DESIGN & CONSTRUCTION MANUAL DESIGN CRITERIA MODIFICATION REQUEST

PROJECT NAME: The Village at Discovery Park Zone 1 – Public Sanitary Sewer Plans

PERMIT NUMBER: PL2023145 (Project #)

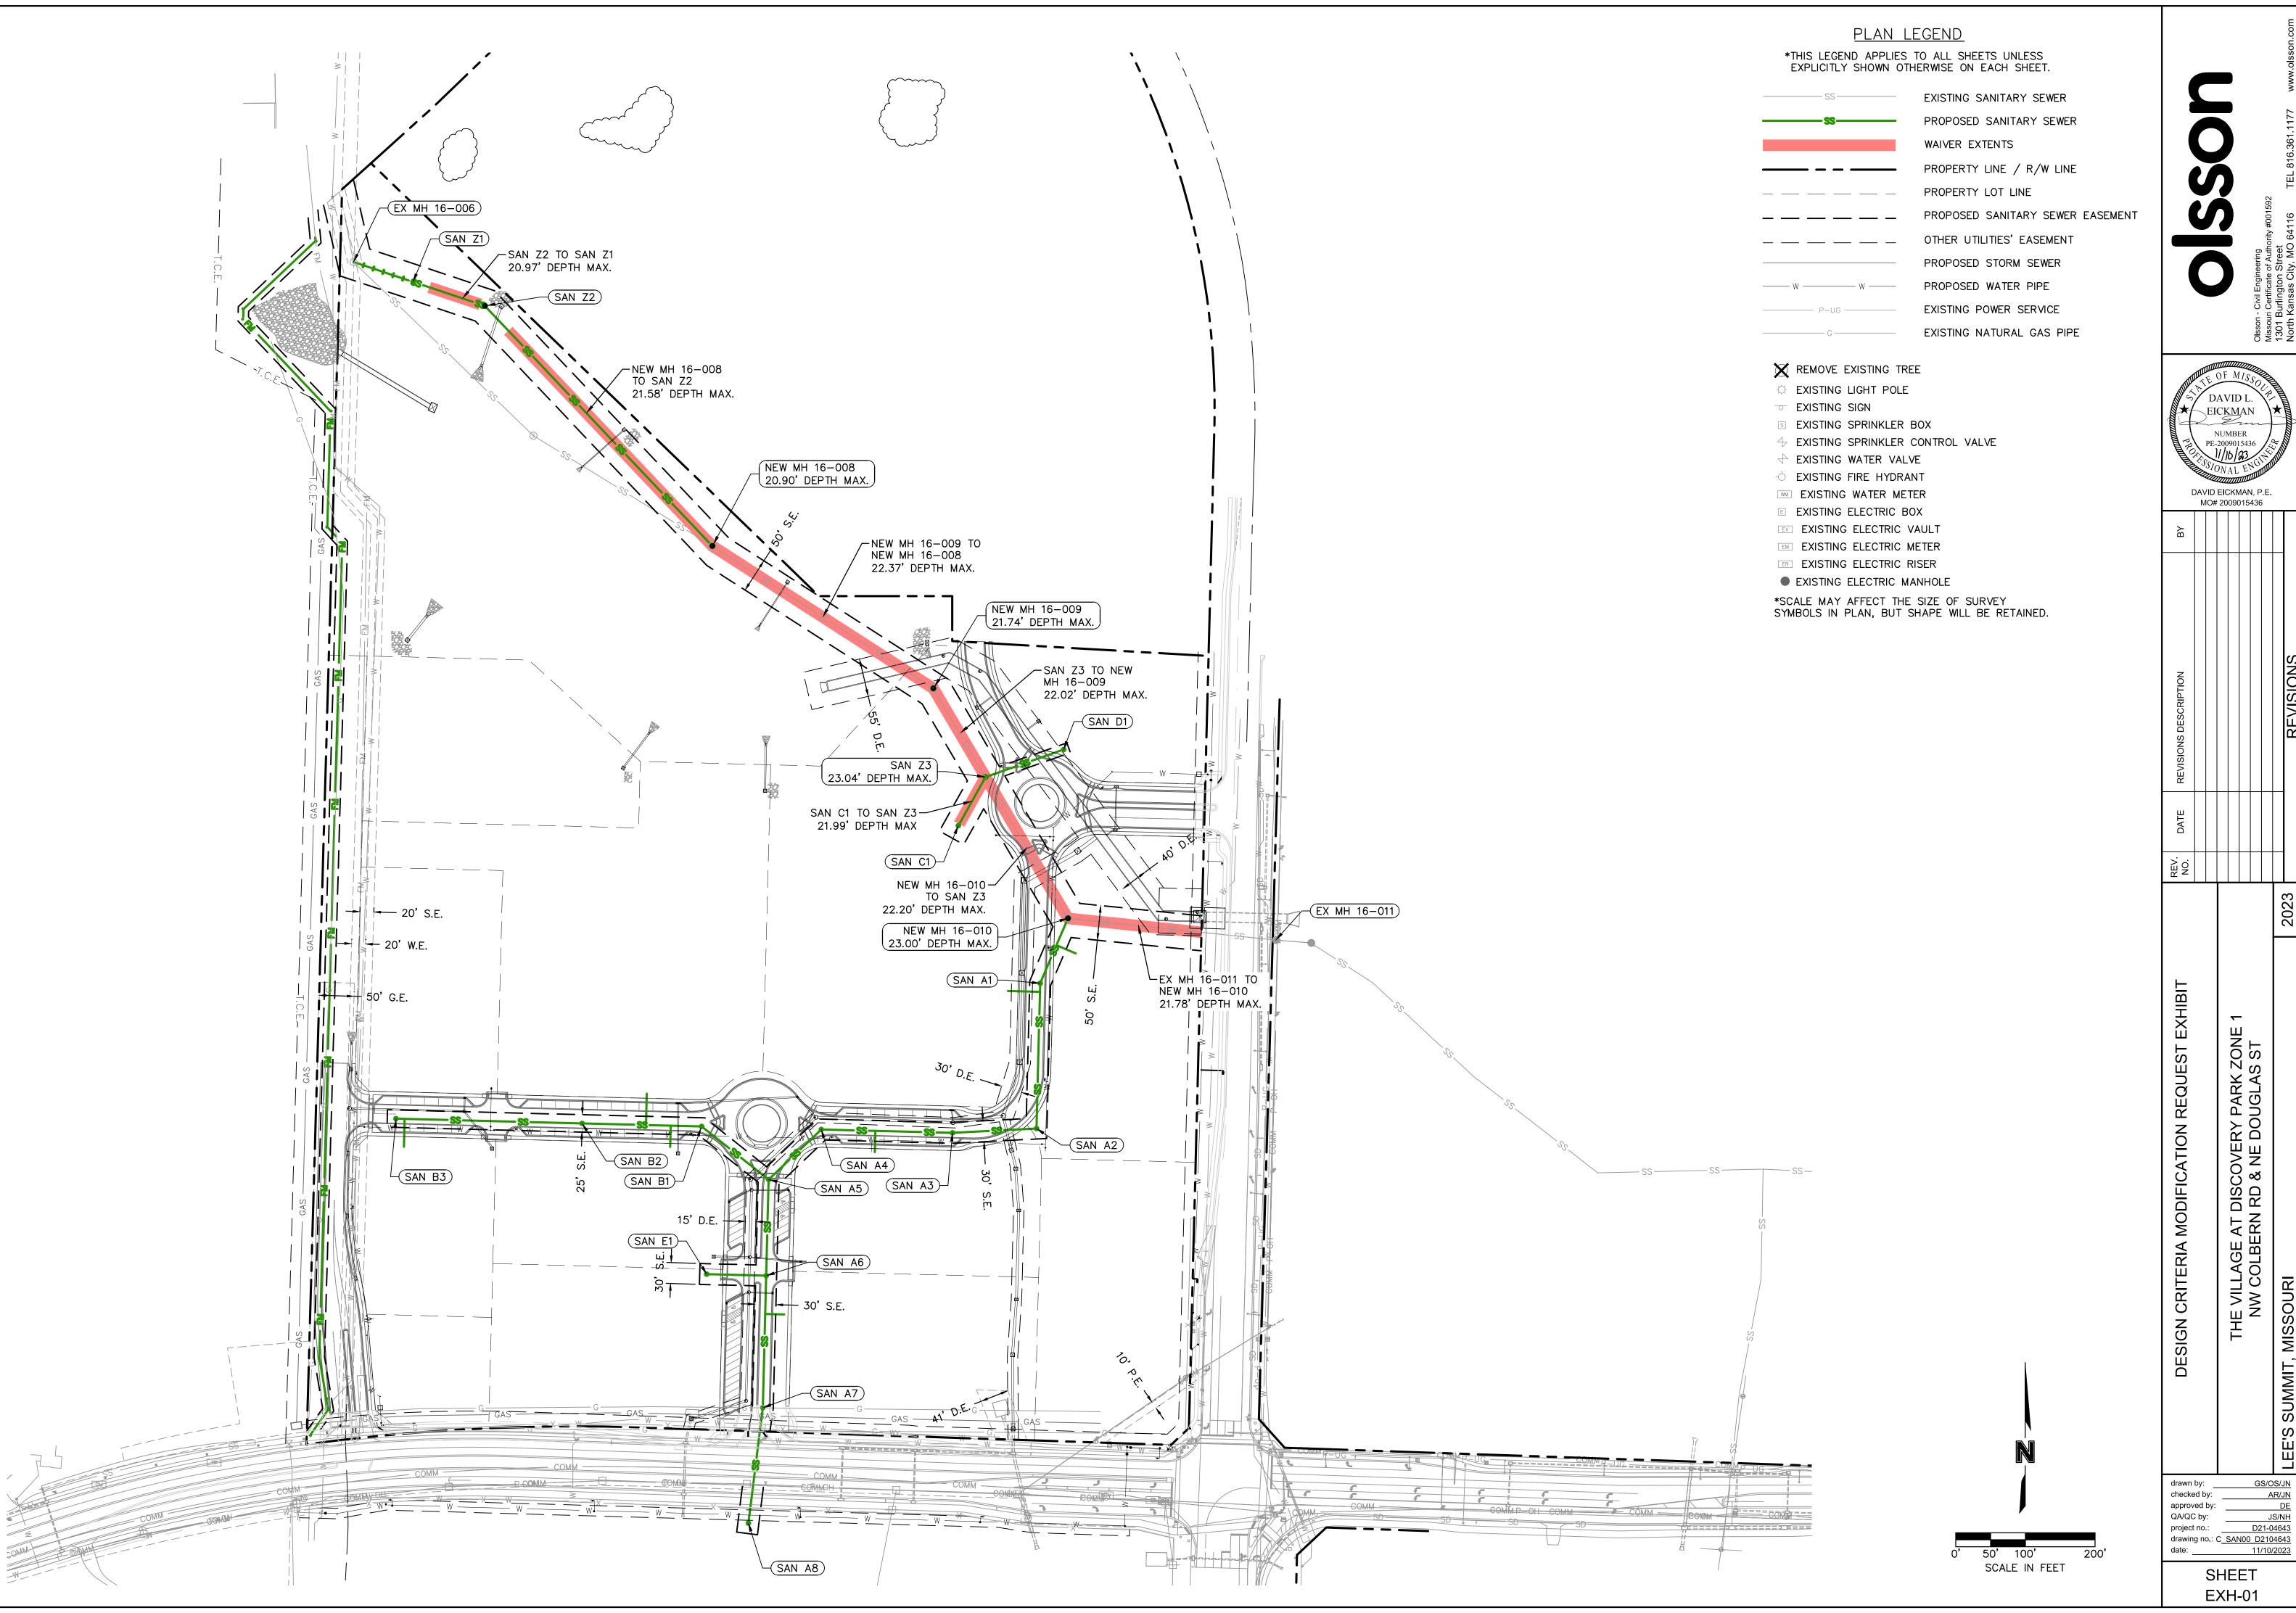
A modification to Section 6501.E.3.a is requested to allow an increase of maximum depth of sanitary sewers and manholes from 20 ft to 23.04 ft. Modification will apply to EX. SANITARY LINE Z (existing 12" sewer main that's partially relocated) shown on sheets C653-C655 of referenced plans.

The sewer main in question will be running along the top of embankment of proposed wet permanent detention basin. The basin geometry and grading are dictated by storm water detention and water quality requirements. Also, since the sewer main is existing, it's flow invert elevations are fixed at upstream and downstream points. Following measures were taken to minimize the depth of the sewer:

- a) proposed pipe run from structure NEW MH 16-008 to SAN Z2 was flattened from 0.67% to 0.40%;
- b) proposed pipe run from structure SAN Z2 to SAN Z1 was flattened from 6.84% to 3.67% and straddle blocks added to pipe run from SAN Z1 to EX MH 16-006, which brought portions of EX. SANITARY LINE Z under 20 ft deep;
- c) proposed pipe run from structure SAN A1 to NEW MH 16-010 was flattened from 5.48% to 1.10% and outside drop was added at NEW MH 16-010, which brought LINE A under 20 ft deep;

Although all the efforts were made to keep the relocated and existing sewer main as shallow as possible, the basin grading and fixed flow invert elevations of the sewer lead to a need in design modification request for portions of EX. SANITARY LINE Z and SANITARY LINE C. Refer to exhibit attached for extents of waiver request and max. depth at each pipe runs and manholes.
